Report on PolyMet Tailings Basin Geology and Proposed Engineering Controls

Paula Maccabee
Attorney for WaterLegacy
1961 Selby Avenue
St. Paul, MN 55104

J.D. Lehr
Professional Geologist
P.O. Box 217
Lutsen, MN 55612

Date: January 4, 2022

FIGURE 12. DRILL HOLES SELECTED FOR PACKER TESTING

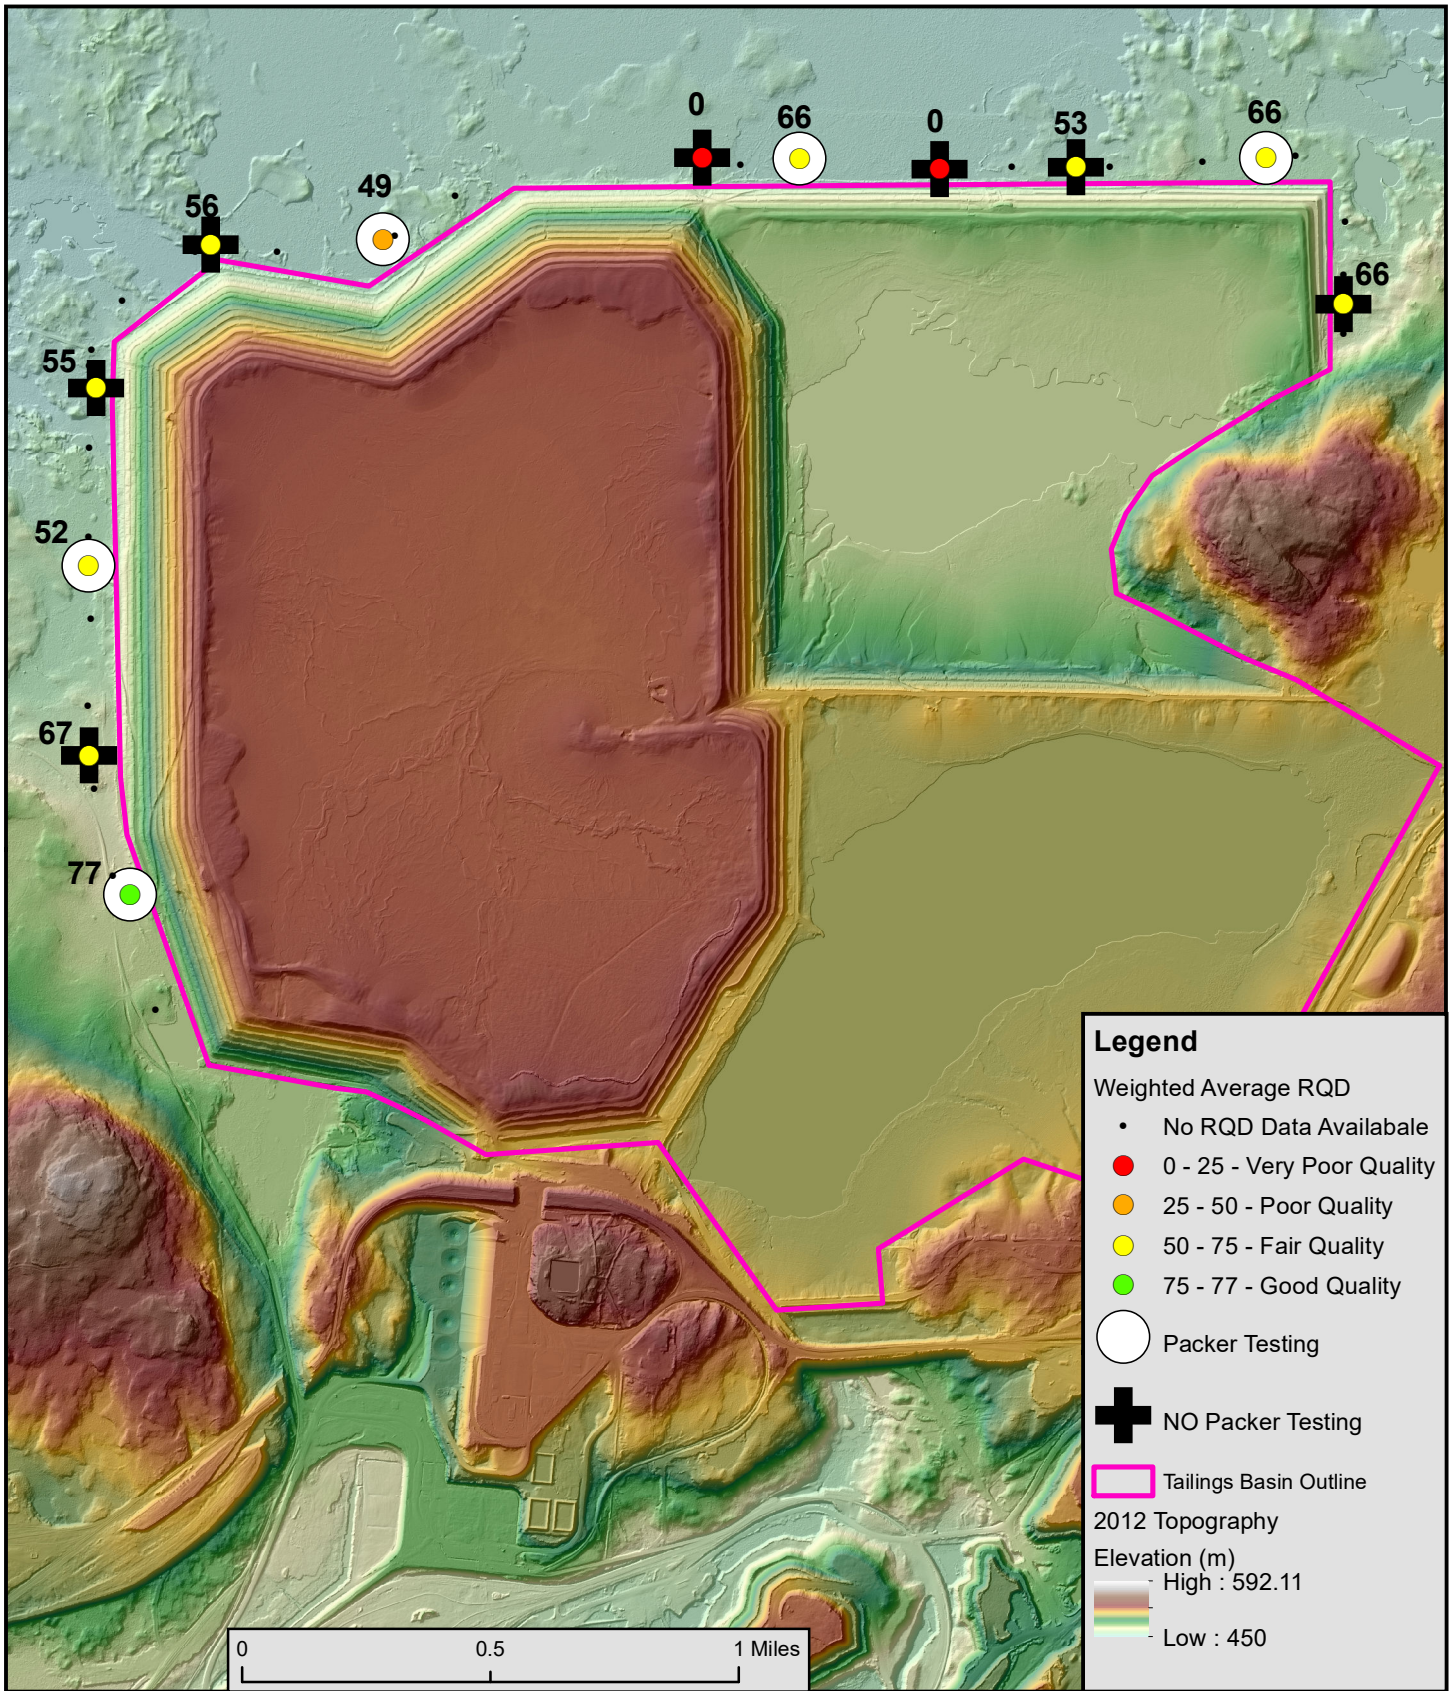
Packer testing was carried out within the bedrock on selected boreholes (Figure 12) and on selected intervals within those boreholes (Tables 7-11). The stated goal of packer testing was to objectively determine how much water moved through bedrock so that these values could then be used in groundwater modeling to predict the efficacy of proposed water pollution controls. PolyMet relied heavily on packer test results to assume that bedrock throughout the tailings basin site is virtually impermeable for modeling purposes. PolyMet claims that “the packer testing interval was determined in the field with the intent to obtain the most representative data possible for measuring the hydraulic conductivity of the bedrock”.⁴⁶

Additional bias was introduced to the packer tests in deciding which drill holes to select for testing. Packer testing was carried out on all drill holes (100%) with weighted average RQD results⁴⁷ greater than 75 and on 2 of the 4 (50%) drill holes with RQD results in the 60's. Of the 5 drill holes with RQD results ranging from 49 to 59, only 2 (40%) were selected for packer testing and none of the drill holes with RQD's less than 49 were chosen (0%) (Figure 12). Notice that for that portion of the seepage capture system alignment immediately down-hydrologic-gradient from the FTB – the north side - packer testing was carried out in the two drill holes yielding the highest RQD results (66). Two drill holes with average RQD's of 0 and another of 53 were excluded from packer testing (Figure 12).

FIGURE 13. POLYMET'S REPORTED DEPTH TO COMPETENT BEDROCK

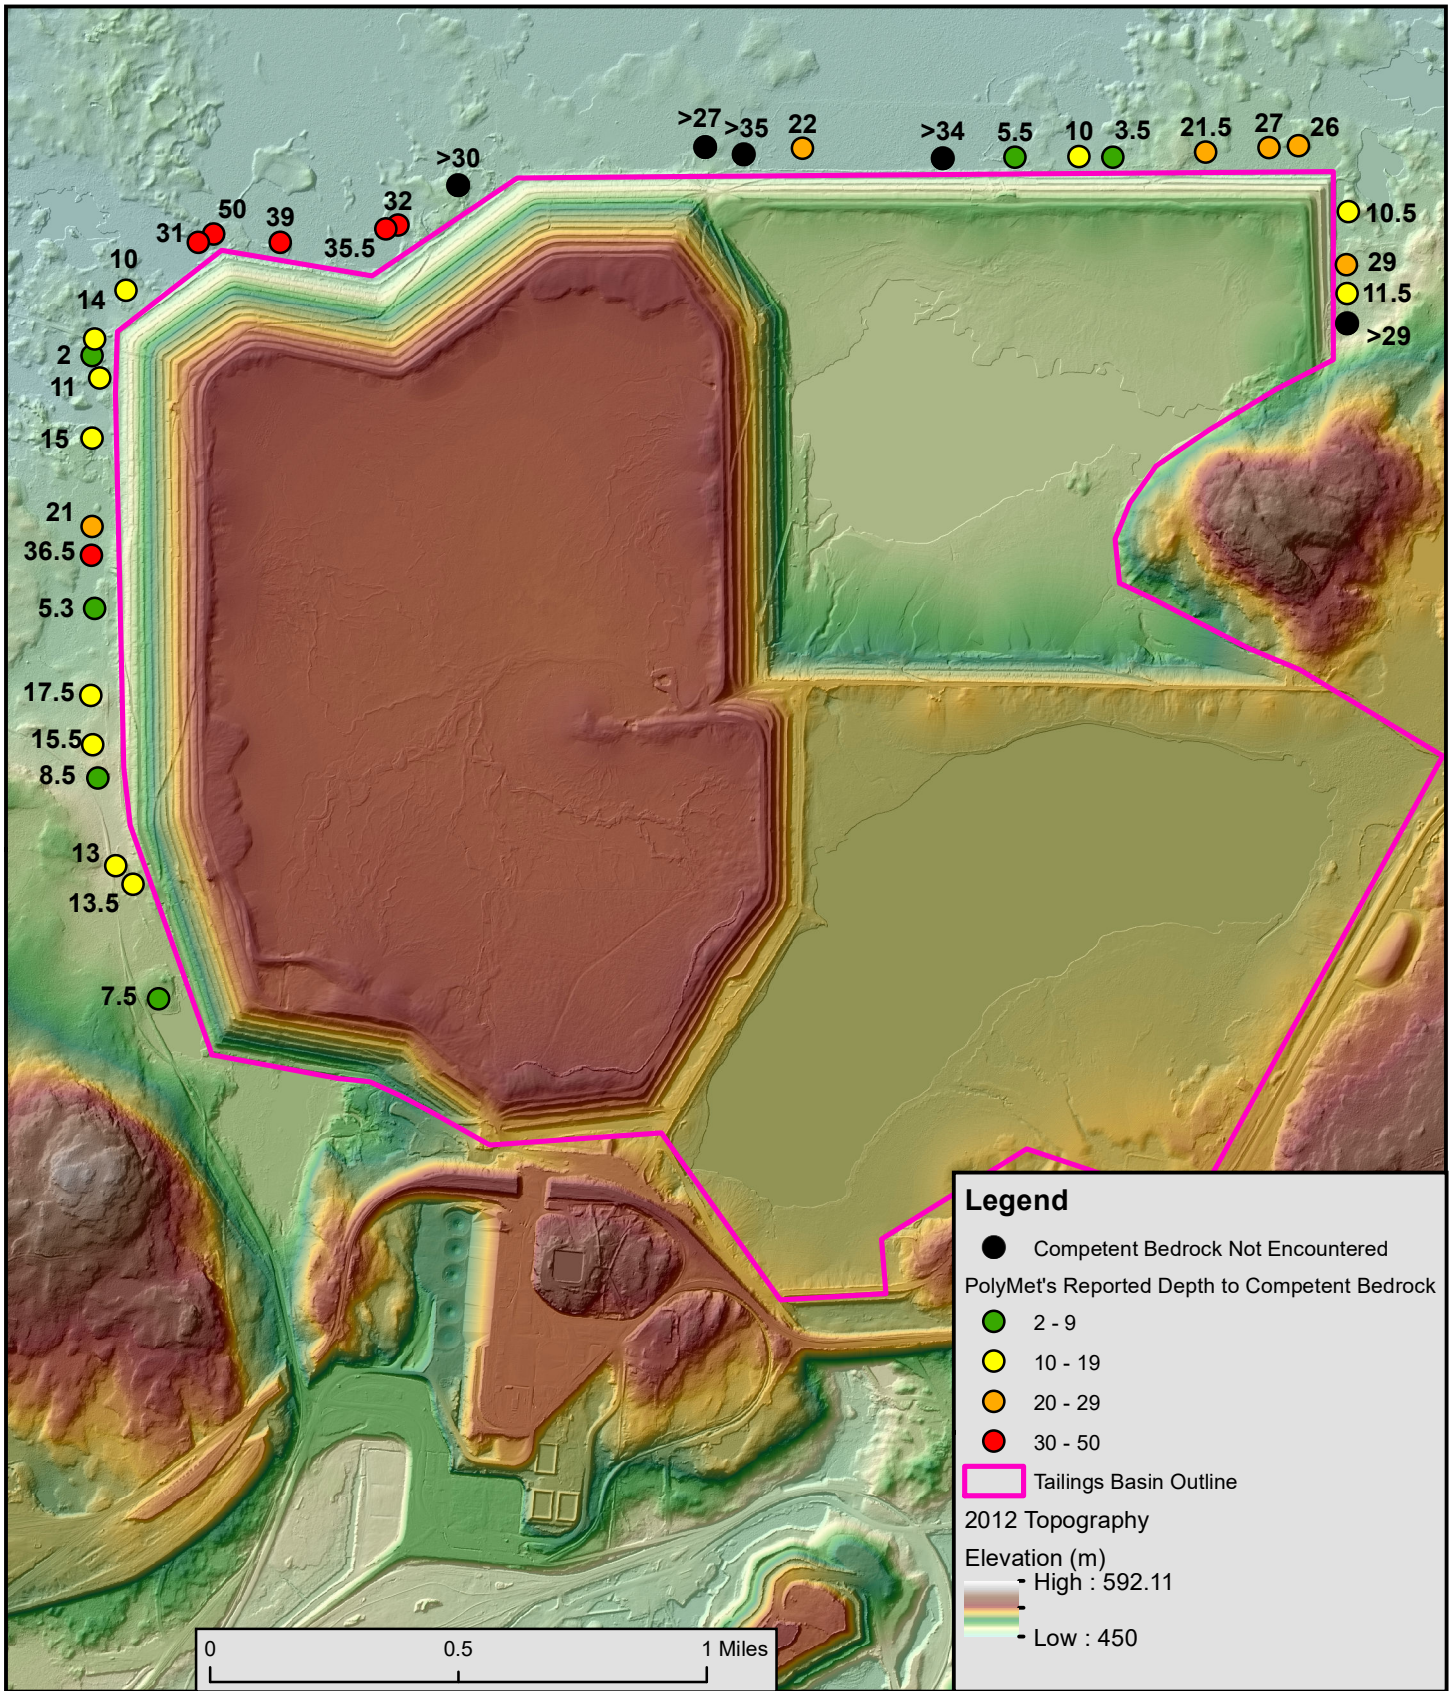
The five drill holes where no competent bedrock was encountered were drilled to depths of 27 to 35 feet (Tables 1 to 4 and Figure 13) and four of the five occur clustered together along the northern margin of the tailings basin (Figure 13). This situation results in a gap along the northern margin of the tailings basin nearly 1.5 miles long where the depth to competent granite bedrock has not been established. There is a second, shorter, segment along the east margin where depth to competent bedrock is also unknown (Figure 13).

FIGURE 15. POLYMET'S REPORTED THICKNESS OF COMPETENT GRANITE DRILLED

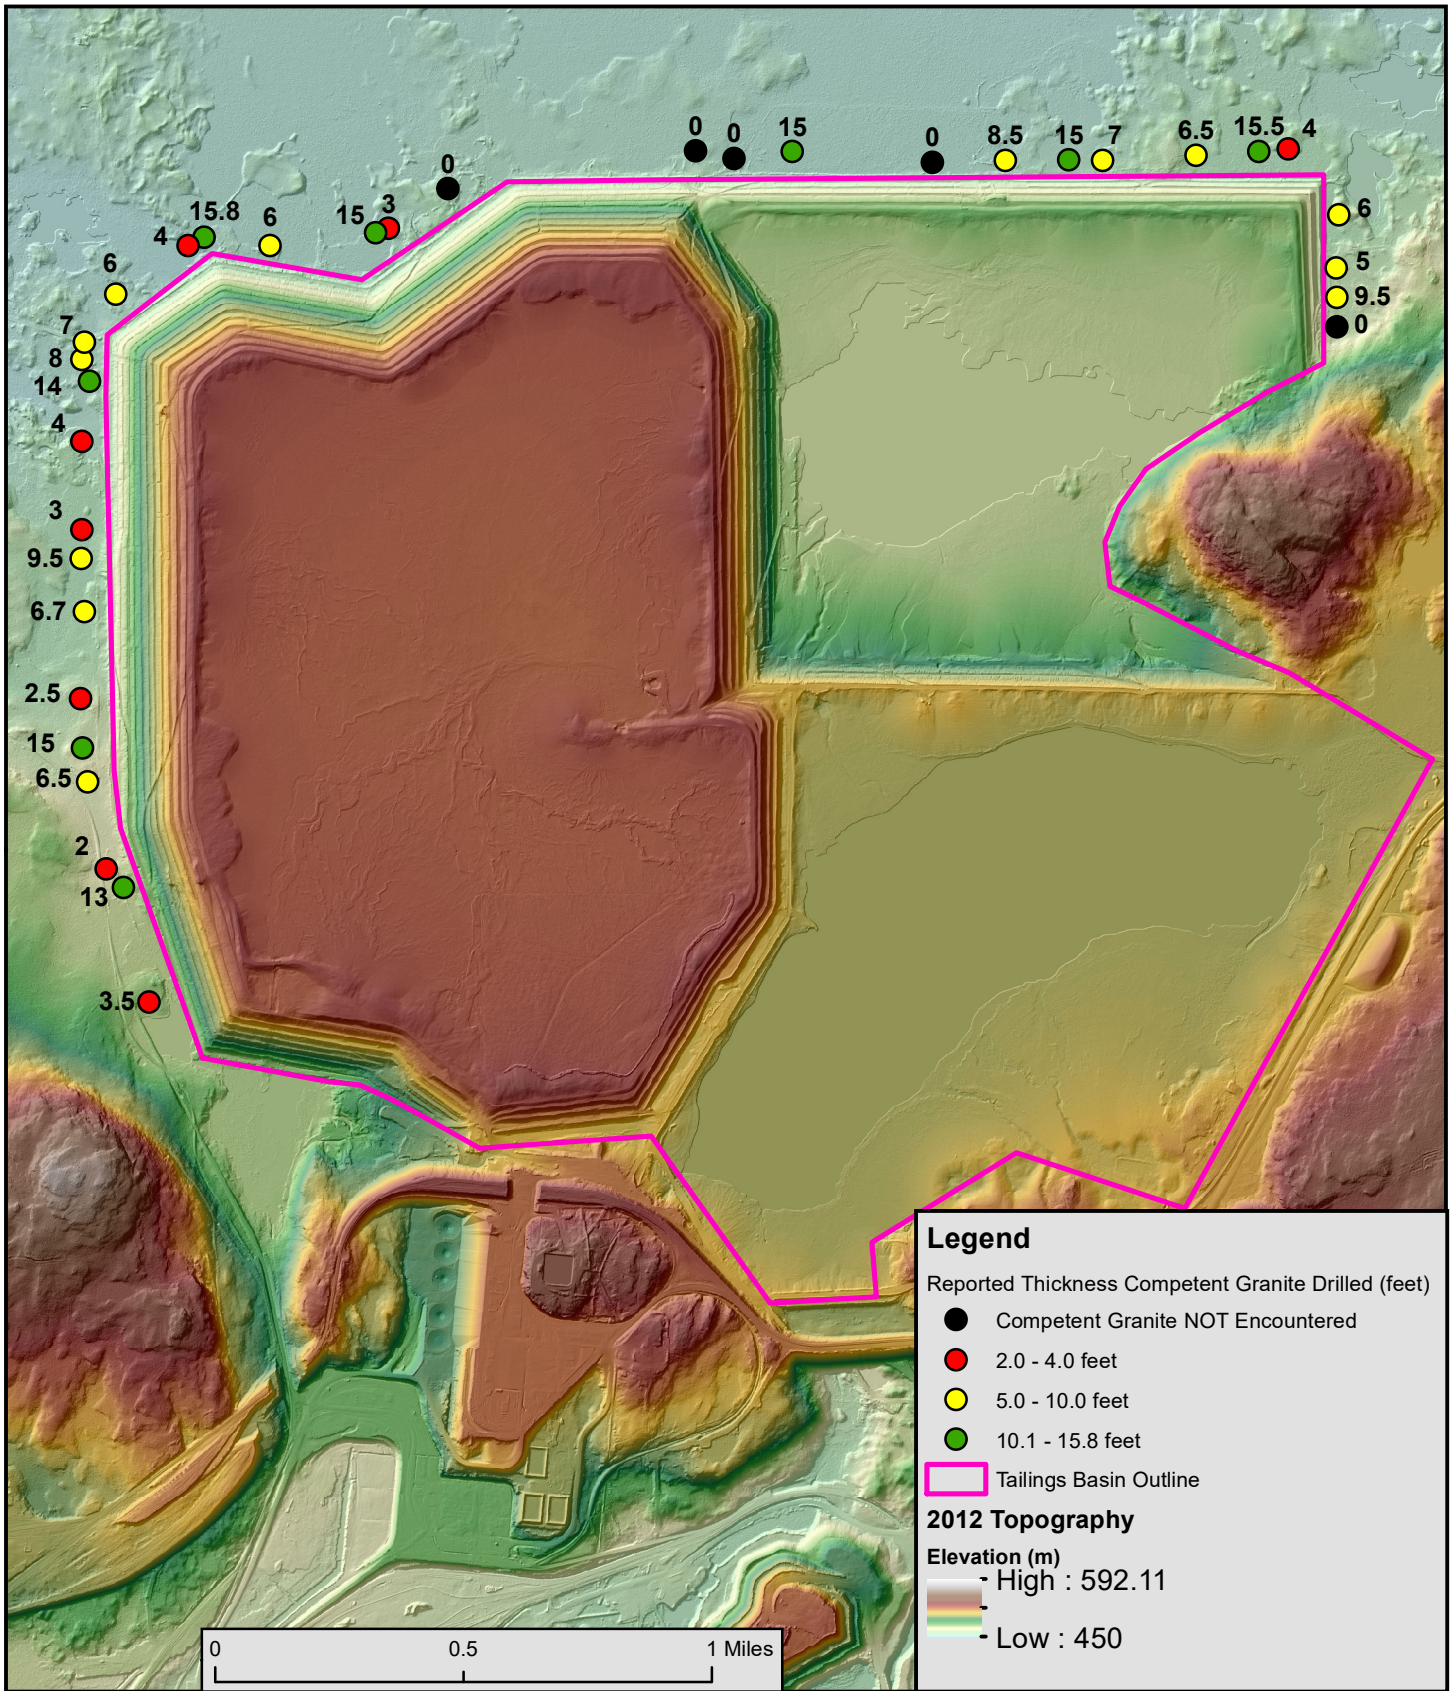
Only 8 of the 34 holes⁵⁸ drilled intersected more than 10 feet of reportedly competent bedrock - the green markers shown on Figure 15. All of the remaining 26 drill holes – the black, red, and yellow markers on Figure 15 – intersected less than 10 feet of bedrock and therefore do not provide sufficient confidence that competent bedrock was reached during drilling at those locations.

In addition to the 5 drill holes where no competent granite was encountered (the black markers on Figure 15), 8 additional drill holes (the red markers on Figure 15)⁵⁹ only penetrated 2 to 4 feet of reportedly competent granite before stopping (Table 1 and Figure 15). The depths to competent bedrock reported in these areas should be considered highly suspect since the commonplace occurrence of large boulders of at least 4 feet in diameter increases the likelihood that at least some of these holes were terminated on boulders instead of competent bedrock.

In summary, 22 of the 34 drill holes in PolyMet’s dataset (65%) either did not encounter any competent bedrock at all or only reported 7 feet or less of sound bedrock and 26 of the 34 drill holes (76%) encountered less than 10 feet of sound bedrock (Table 1, Table 2, and Figure 15). As shown in Figure 15, this results in a gap along the north boundary of the tailings basin of nearly one and a half miles where only a single drill hole⁶¹ confidently defines the depth to competent bedrock along the proposed slurry wall alignment (Figure 15).

FIGURE 16. DRAWING SHOWING SLURRY WALL “KEYED TO COMPETENT BEDROCK” Source: Final EIS, p. 1068. Note: the original drawing from the Final EIS has been modified here by adding in red the explanation of the “keyed into bedrock” relationship that the original drawing shows but does not label.

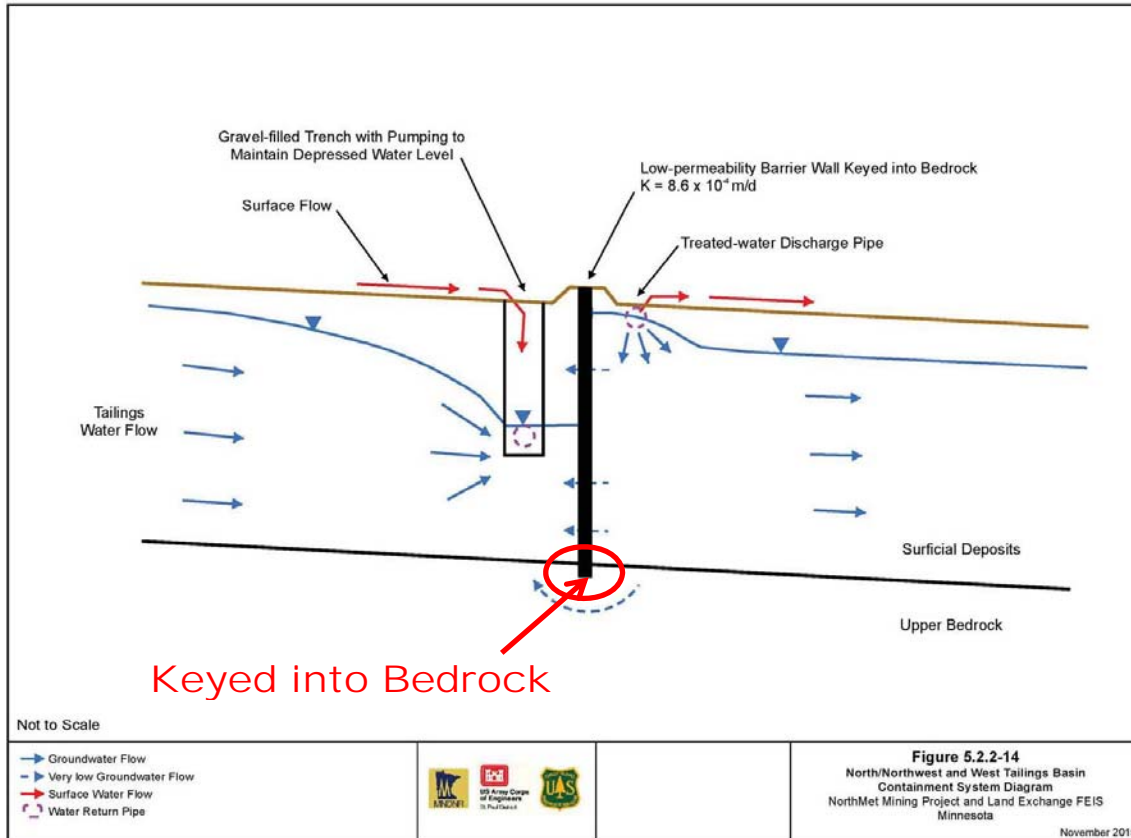
In order for the slurry wall to meet permitting conditions and claimed pollution control efficacies it must be constructed so that it is “keyed to competent bedrock.” However no explanation is provided of how the bentonite slurry wall will be “keyed to competent bedrock” at great and still uncertain depths and into solid granite bedrock. This is not a detail that can be left to future “adaptive management” if difficulties are encountered during construction or the seepage collection system fails to perform. If the bentonite slurry wall is not properly keyed into bedrock (Figure 16), larger-than-predicted volumes of untreated groundwater seepage will pass beneath the slurry wall, bypassing capture by the pumping network and adversely affecting the environment.
